From: Martin Gillam [Redacted]
Sent: 11 July 2020 20:59
To: Anita Gardner <Anita.Gardner@arun.gov.uk>
Subject: FW: CM/16/20/PL

The Officers report for CM/64/19/PL states:

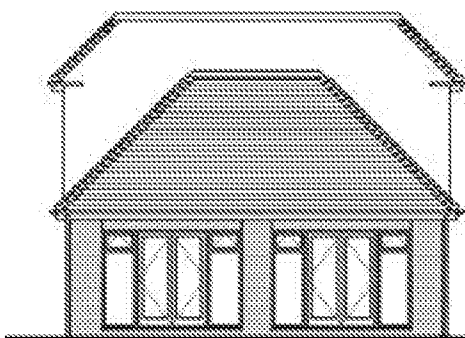
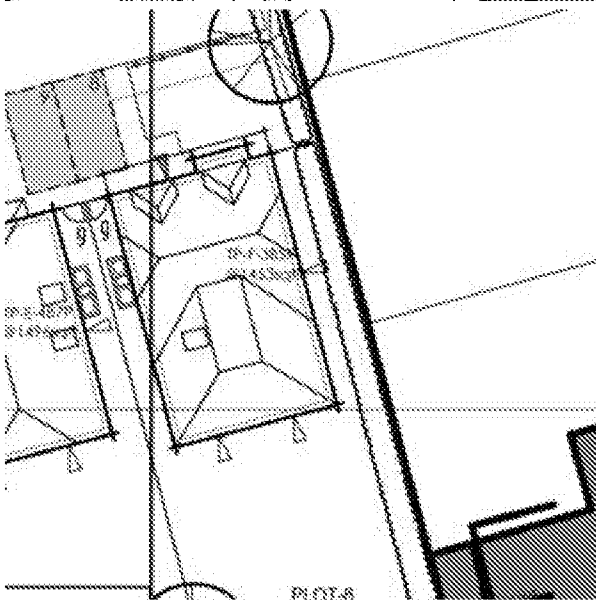
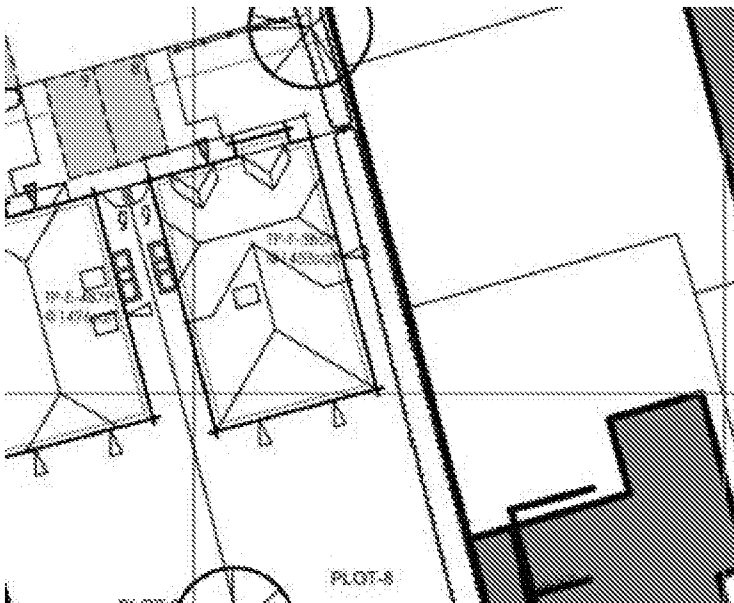
Regarding the approved plans (CM/64/19/PL) I am concerned by the lack of key measurements such as not stating the pitch and height of the roof or the distance to the boundary. The plans were also frequently changed and there are inconsistencies which make it very difficult to review. For example the roof of plot 8 started as a pitched roof with gable windows, then it shows a flat roof at the back, then a flat roof at the back front and the gable windows are gone. See below:

Rear elevation

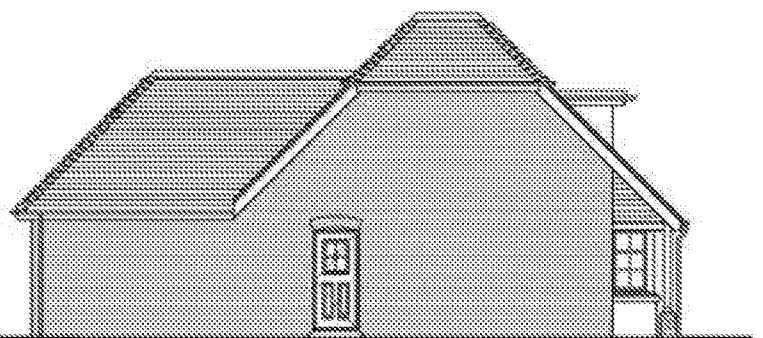
I am not sure why the architect made these changes or neglected to state important measurements but it is nonsensical that they now want to re-design the house because they are not happy with flat roofs.

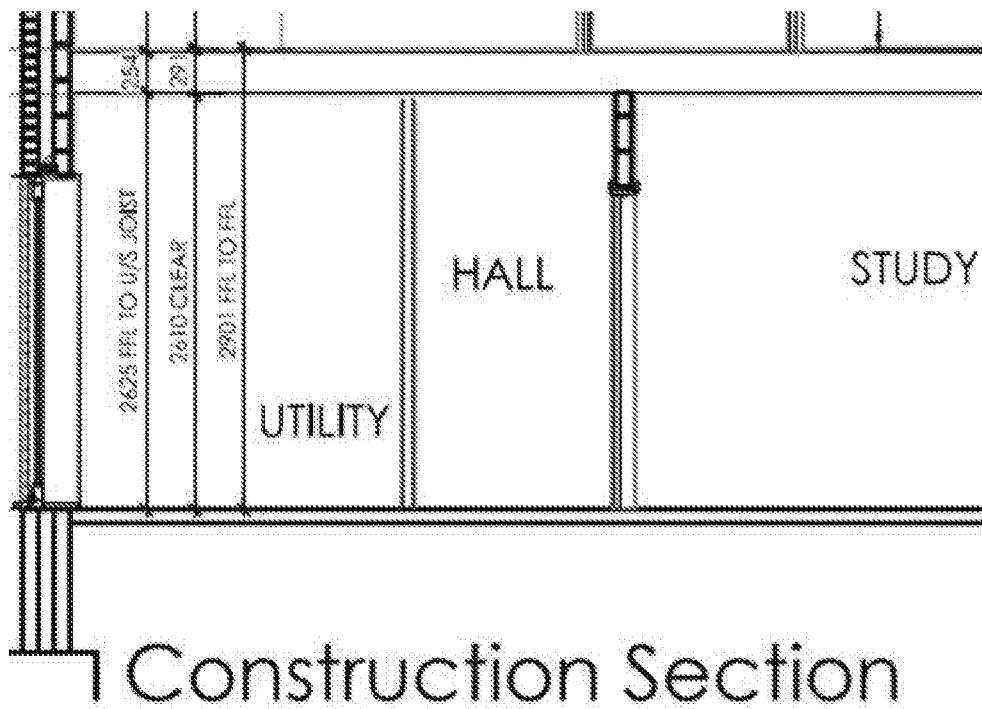
The architect has just added a "construction section", the ceiling height of the house is taller than standard. The plans state that the ground floor to the underside of the joist is 2625mm –see below. Normal ceiling height is just

over 2.3m. I and other neighbours have expressed concerns about massing, scale and light infringement therefore it is unacceptable that the architect wants to have abnormally high ceilings and the original application makes no mention of this.
